AIRGAIN[®] SKYWIRE[®] NL-SW-LTE-TC1NAG NL-SW-LTE-TC1NAG-B

Product Change Notification - End of Life (EOL)

2.2 Label Orientation and Branding Changes

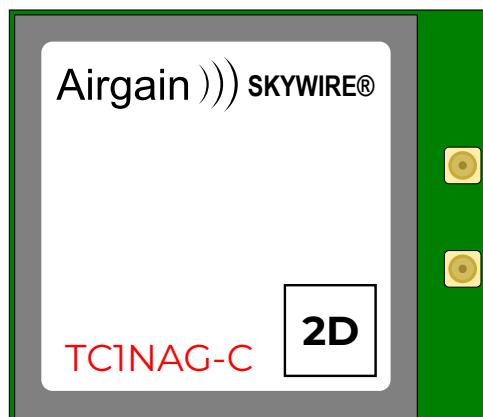
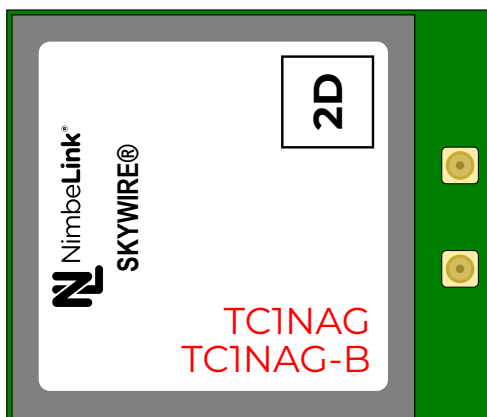
The NL-SW-LTE-TC1NAG-C label design has also been modified. The label has been rotated 90 degrees and the branding has been changed from NimbeLink to Airgain. This change is cosmetic and does not affect the label contents (IMEI, ICCID, etc.) or the barcode encoding.

If your manufacturing process includes visual inspection of Skywire modem labels and/or barcode scanning, Airgain recommends reviewing manufacturing work instructions and confirming that scanning equipment can accommodate the new orientation.
